# CITY OF ALBUQUERQUE

**RE: 6309 Little Joe Dr. NW**  
**Grading and Drainage Plan**  
**Engineer's Stamp Date: 08/14/21**  
**Engineer's Certification Date: 09/03/21**  
**Hydrology File: E10D109**

## DRAINAGE AND TRANSPORTATION INFORMATION SHEET (REV 6/2018)

ENGINEER'S SEAL  8/14/21 DAVID SOULE P.E. #14522	LOT 14 BLK 7A UN 3 VC 6309 LITTLE JOE GRADING AND DRAINAGE PLAN  P.O. BOX 53924 ALBUQUERQUE, NM 87199 (505) 321-9099	DRAWN BY: DEM DATE: 8-14-21 Lot 14 Blk 7a Un 3 VC.DWG SHEET # C1 JOB #

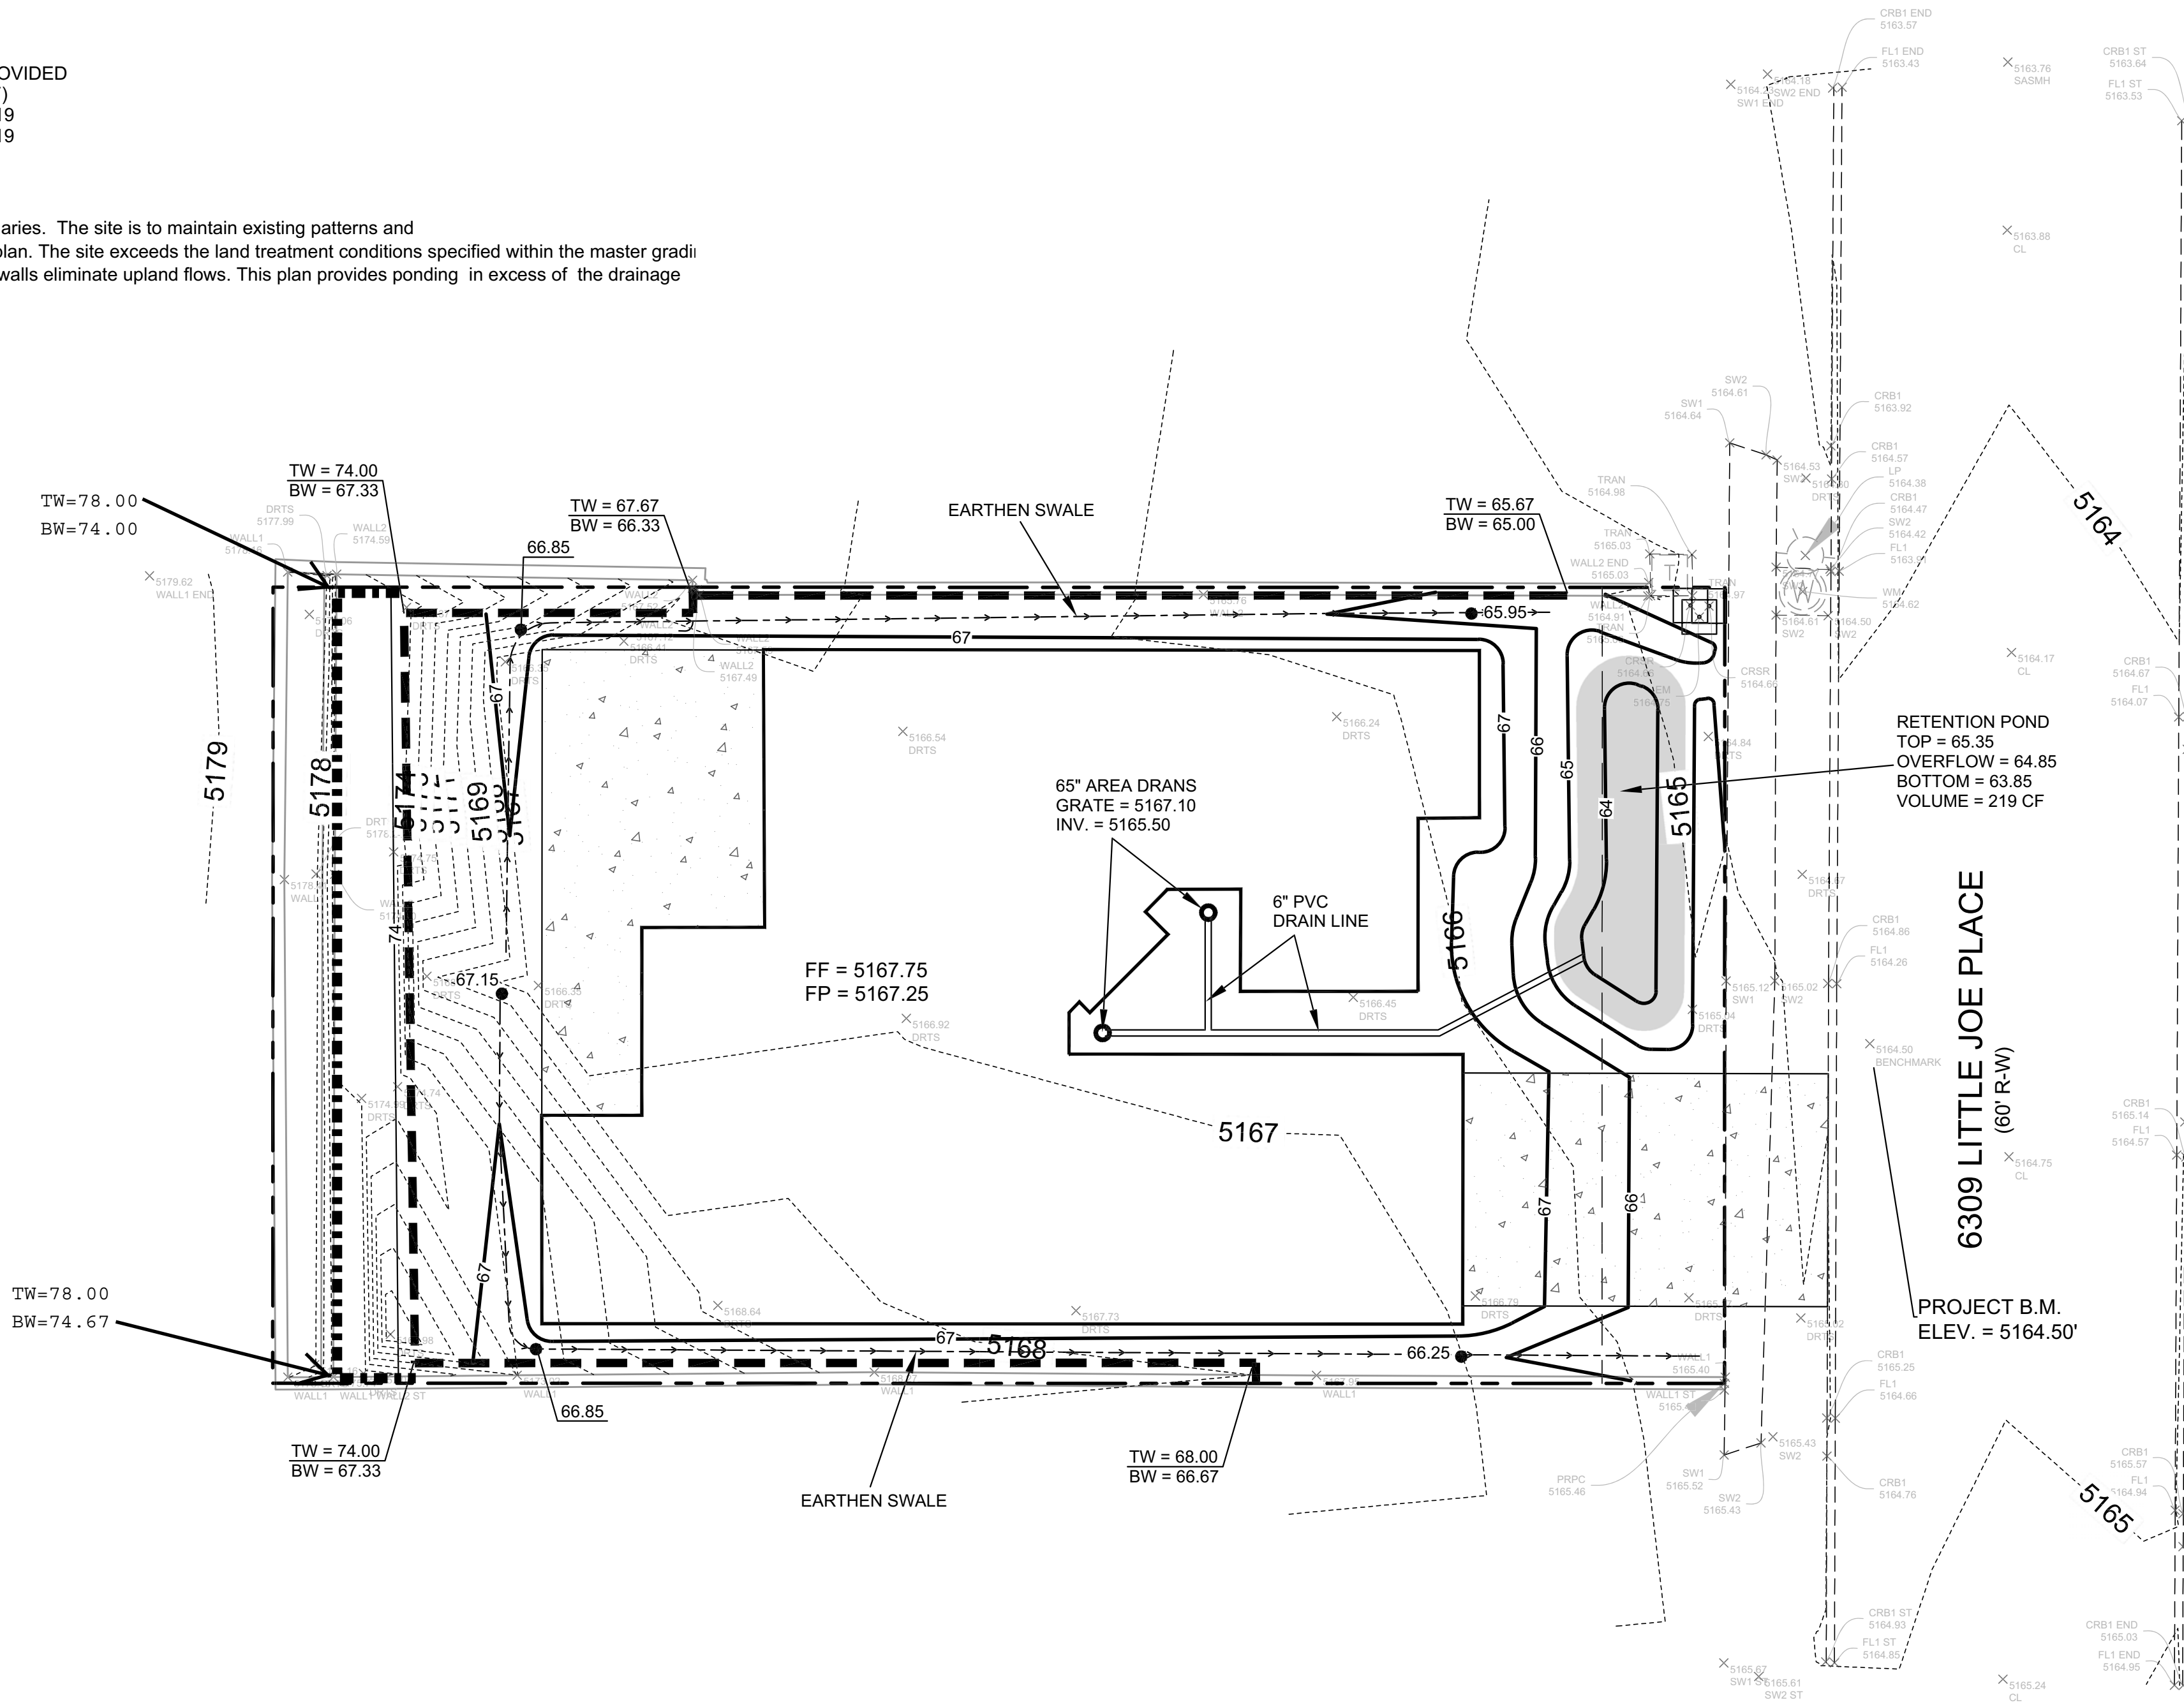
Based upon the information provided in your submittal received 09/03/2021 and site photos sent on 09/03/21, the Grading and Drainage Plan is approved for Building Permit, Grading Permit, and Building Pad Certification for 6309 Little Joe Dr. NW. Please attach a copy of this approved plan in the construction sets for Building Permit processing along with a copy of this letter.

Prior to approval in support of Permanent Release of Occupancy by Hydrology, Engineer Certification per the DPM checklist will be required.
